VISUAL SITE INSPECTION REPORT - 2015

**SOUTHERN INDIANA GAS AND ELECTRIC
A. B. BROWN GENERATING STATION
TYPE III RESTRICTED WASTE LANDFILL
WEST FRANKLIN, IN**

ATC PROJECT NO. 170LF00159

Subject: Visual Site Inspection Report - 2015
A. B. Brown Generating Station
Type III Restricted Waste Landfill
West Franklin, Indiana
ATC Project No. 170LF00159

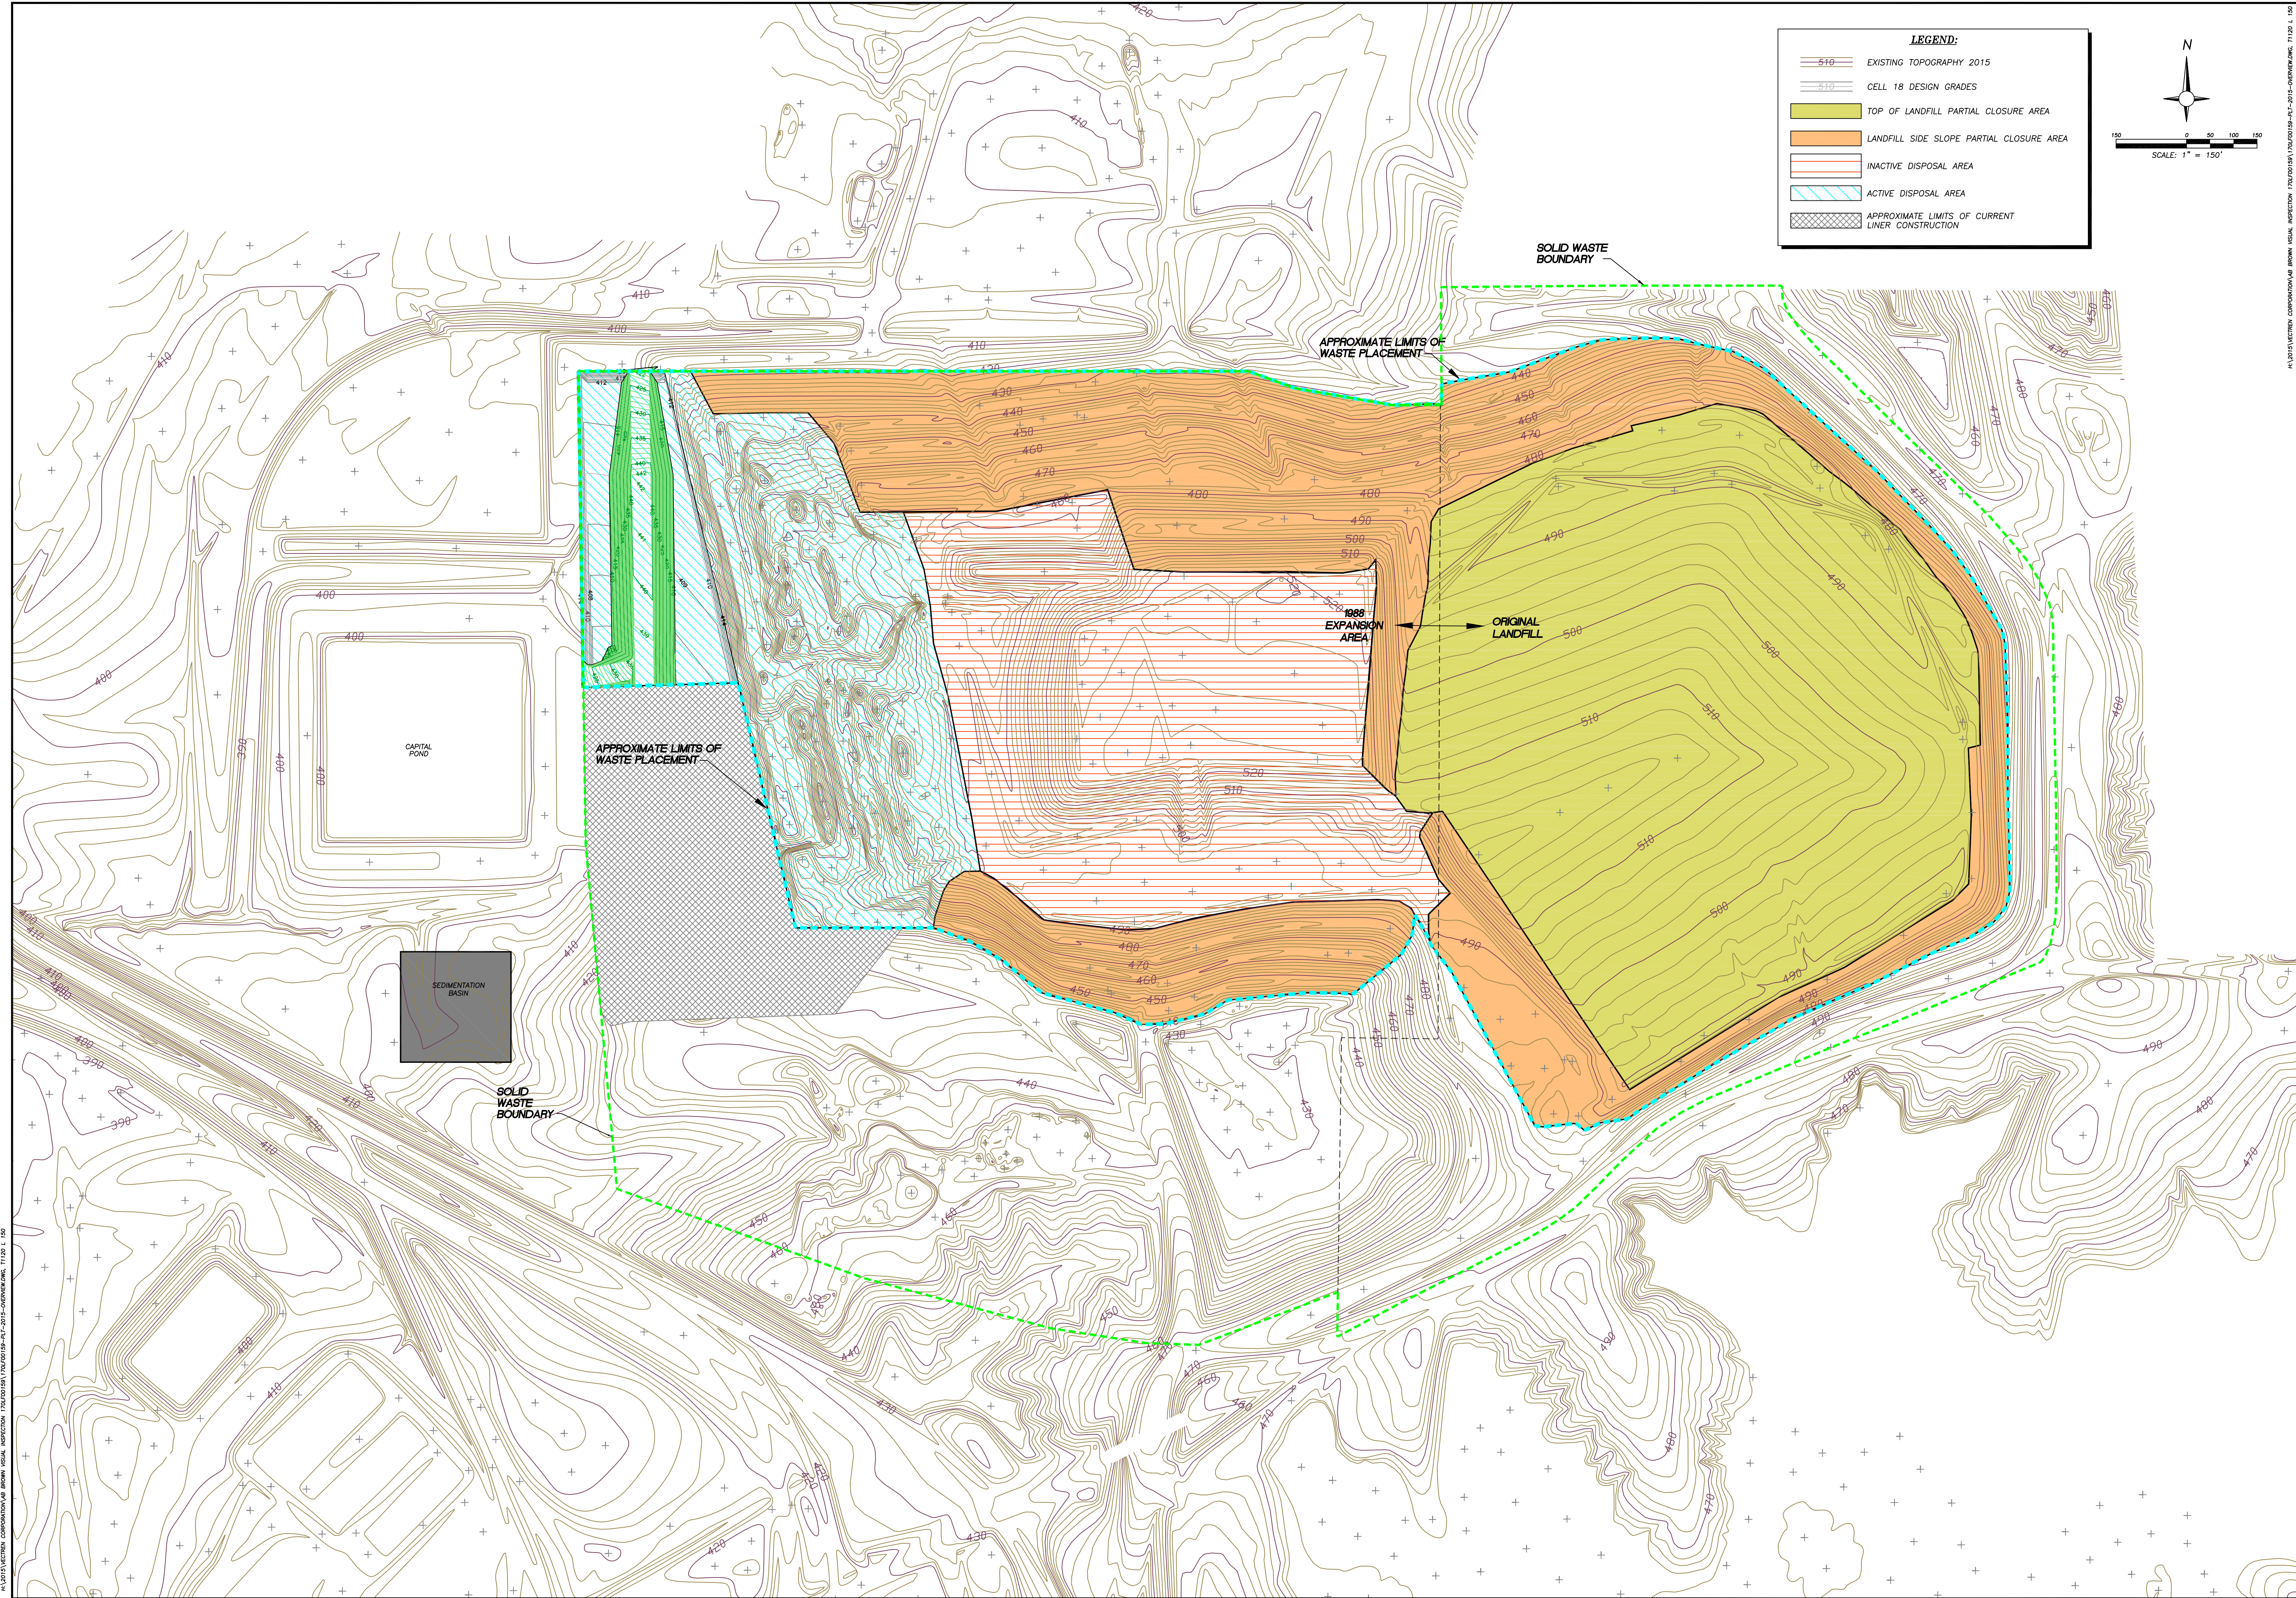
- 1) The area is generally well vegetated and well maintained; however, there are some isolated areas with sparse vegetation and areas near drainage structures where the vegetation is overgrown.
Recommendation: Overseed and fertilize the areas of sparse vegetation as part of the ongoing maintenance program. Cut the vegetation around the drainage structure inlets to allow unobstructed flow into the structure.

- 2) There were areas of standing water and poor vegetative cover north and south of the diversion berm.
Recommendation: Adjust the final grades as needed to prevent the ponding of water and revegetate all areas with sparse vegetation and/or disturbed by these modifications.

- 3) At isolated locations along the diversion berms surrounding the partial closure area, some minor erosion gullies were noted on the interior and exterior slopes.
Recommendation: Fill in erosion gullies and reseed the disturbed areas as part of the ongoing maintenance program.

- 4) Animal burrows were noted at isolated locations within the limits of the partial closure area.
Recommendation: Repair animal burrows and implement an animal control program.

- 1) The sideslopes with final cover are generally well vegetated and well maintained; however, there are some isolated areas with sparse vegetation and erosion.
Recommendation: Overseed and fertilize the areas of sparse vegetation as part of the ongoing maintenance program. Backfill eroded areas and vegetate all areas disturbed by the repairs.

- 2) There are seeps discharging from the south slope. The combined flow rate at the time of this visual inspection was estimated to be approximately 1 gpm. The area in the vicinity of the seep was also covered with phragmites indicating high moisture content in the cover soils in this general area. Flow from the area is currently collected in a piping system and discharged to the Capital Pond. Standing water was noted behind the diversion berm present above the area where the seeps were noted.
Recommendation: Continue to collect water discharging from the seeps until repairs can be made. The diversion berm present above this area should be regraded to drain to remove this possible source of water for the seeps. If the seeps continue to flow following repair of the diversion berm, it will likely be necessary to either add additional cover soils in the vicinity of the seeps, or modify the seepage collection system.

- 3) Some of the diversion berms on the south side of the landfill discharge into downdrain pipes. The entrances to some of the downdrain pipes were overgrown causing obstructed flow into the pipes. Based on the presence of several small depressions both at some of the inlets to the downdrains and along the downdrain alignment, it appears that some water is flowing along the outside of the pipes causing a loss of ground at isolated locations.
Recommendation: Remove vegetation from the entrance of the downdrain pipes. Backfill all depression noted around the pipe entrances and along the pipe alignment. Revegetate all areas disturbed while making these repairs.

- 4) Significant erosion was noted around the outlet end of the downdrain pipes present at the southeast corner of the landfill). At most locations, the perimeter ditch that receives the discharge from the outlet pipes is protected with a riprap plunge pool. However, at this location there is no riprap lined plunge pool. The discharge from the downdrain pipe is eroding the base of the perimeter ditch and undercutting the outlet end of the downdrain pipe.
Recommendation: Riprap should be placed below the outlet pipes to protect the ditch from erosion. Erosion around these pipes should also be repaired.

- 5) The downdrain pipes and the riprap lined downchutes on the north side of the landfill are generally in good condition. A collar connecting two segments of one of the downdrain pipes has separated, causing the pipe ends to also separate. In addition, a portion of a corrugated

plastic pipe that conveys water from a diversion berm, under an access road and into a riprap lined downchute, has been damaged and is no longer functioning as intended.

- 6) A seep is present on the north slope near the east end of the landfill. A trench has been excavated in the area to collect the seep water and convey it in pipes to the Capital Pond. It is our understanding that the flow rate varies seasonally and that the peak rate decreased following the construction of the composite final cover across the top of the east end of the landfill.
Recommendation: Continue to collect and convey the seep water by discharging to the Capital Pond.

- 7) Animal burrows were noted at isolated locations within the limits of the partial closure area.
Recommendation: Repair animal burrows and implement an animal control program.

- 8) On the western facing slope adjacent to the final cover on the east end there is a washout along a downdrain pipe. The western slope was recently seeded and mulched, but the vegetative cover has not yet been established.
Recommendation: Repair the erosion gully and reseed/mulch the slope. A riprap lined plunge pool should be installed at the outlet of the pipe to minimize the potential for additional erosion. The area should be monitored during weekly inspections until a vegetative cover has been established.

- 9) There is an area of ponded water at the toe of the west end of the north facing slope in a ditch. This standing water appears to be caused by the fill used to make the roads.
Recommendation: The area should be regraded to prevent the ponding of surface water.

- 1) In general, the vegetation across the majority of the inactive area is in good condition with some isolated areas of sparse vegetation and minor erosion on the interim cover of the inactive landfill.
Recommendation: Overseed and fertilize the areas of sparse vegetation as part of the ongoing maintenance program.
- 2) Some minor erosion was noted at the downdrain pipe inlet on the north side of the inactive area.
Recommendation: Erosion should be repaired and monitored to ensure the water is flowing into the downdrain pipes.

- 3) Ponded surface water was noted on the south side of the inactive area.
Recommendation: Regrade the area to prevent the ponding of surface water over the waste.

- 1) The edge of the exposed waste in the north end of Cell 17 is at approximately the same elevation as the final cover to the north. Surface water runoff from the waste piled at the north end of Cell 17 enters this area where it is detained. During a significant storm event it appears that water that has been in contact with the waste could be released onto the final cover slope to the north. At the time of this inspection, construction was in progress in this general area to regrade the waste and apply an interim cover.
Recommendation: If the waste is not regraded and covered with soil, a stormwater diversion berm should be installed to prevent the release of contact water.

- 2) At the time of this visual inspection, water was ponded in the base of the unfinished end of Cell 18. The landfill operator indicated that a pump is normally in place to remove surface water from this area.
Recommendation: Reinstall the pump to prevent the ponding of surface water in the vicinity of the active fill area.

- 3) The west slope of the recently constructed haul road on the west side of Cell 18 is steep. Erosion gullies in excess of 4 ft deep and shallow sloughs were noted at multiple locations along this slope.
Recommendation: Although the haul road is located outside of the solid waste boundary of the landfill, its overall stability is an integral part of the performance of the landfill. Therefore, it is recommended that corrective measures be taken to revise the west slope to ensure long term stability and control erosion.

- 3) There are small erosion gullies forming along the perimeter ditches of the sediment basin.
Recommendation: Repair and vegetate the erosion features as part of the ongoing maintenance of the landfill area.

- 4) There is a small erosion gulley forming in southeast corner of the berm surrounding the sediment basin.
Recommendation: Repair and vegetate the area of erosion.

- 1) The upstream and downstream slopes of the Capital Pond were grass covered and in generally good condition. However, there was evidence of minor erosion in some areas of the slope.
Recommendation: Repair and vegetate the erosion features as part of the ongoing maintenance of the landfill area.
- 2) Standing water and phragmites were noted in the ditch north of the settling pond.
Recommendation: Improve drainage in the area to prevent the ponding of water along the toe of the embankment.

Recommendation: Repair the separated collar and the damaged section of the pipe exposed in the base of the access road.
